STAFF DESIGN COMMISSION REPORT

Project Name: Favia Dental
Project Address: 300 E. Northwest Highway
Prepared By: Steve Hautzinger

DC Number: 17-143
Petitioner Name: Dr. Joe Favia, Favia Dental
Petitioner Address: 300 E. Northwest Highway
Arlington Heights, IL 60004
Meeting Date: November 28, 2017

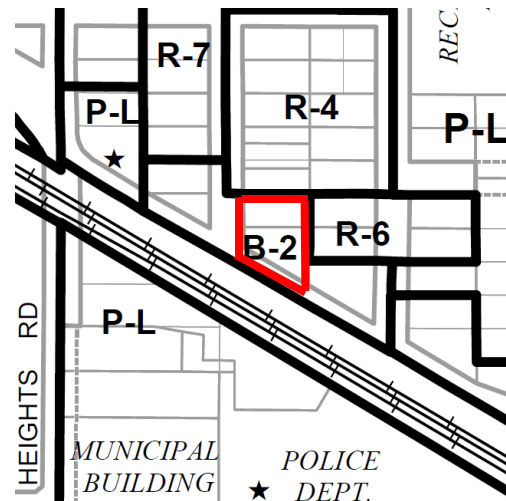
Favia Dental has an existing pole-mounted ground sign facing Northwest Highway. The existing sign is located in a narrow landscape island, and it overhangs above the parking lot driveway in front of the building. Code requires a minimum twelve feet of clearance to the underside of the sign to allow vehicles to safely pass beneath the sign. The existing sign is non-compliant with only ten feet of clearance. The sign is also non-compliant with a zero foot setback, where three feet minimum is required. The petitioner is proposing to replace the existing sign cabinet assembly in its entirety to match the existing sign. Per Chapter 30, Section 30-121 regarding non-conforming signs, the sign is not allowed to be replaced unless it is made to conform with the sign code regulation. Therefore, sign variations are required. The existing pole and lexan sign panels are proposed to be reused.

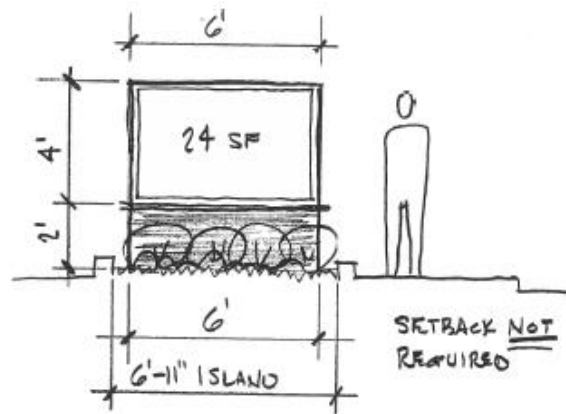
Option 1. A vertically designed code-compliant sign with a three foot setback to fit within the existing landscape island in the same location as the existing sign.

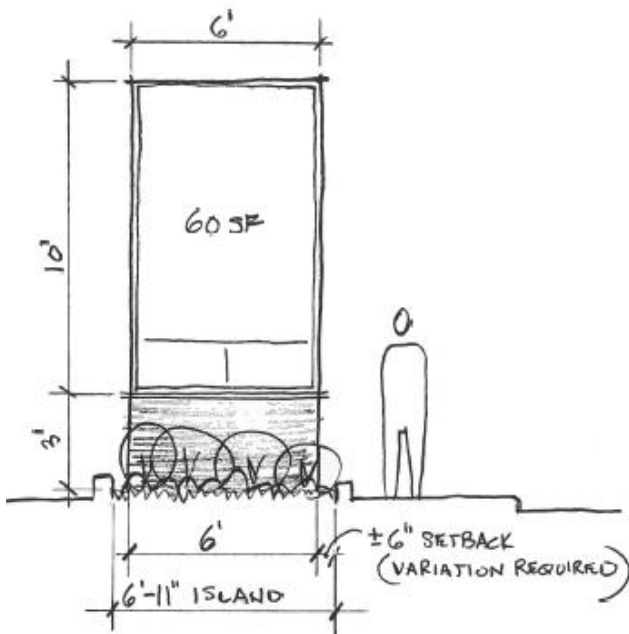
Option 2. A code-compliant monument style sign to fit within the existing landscape island. Monument style signs (six feet tall maximum) have no setback requirement.
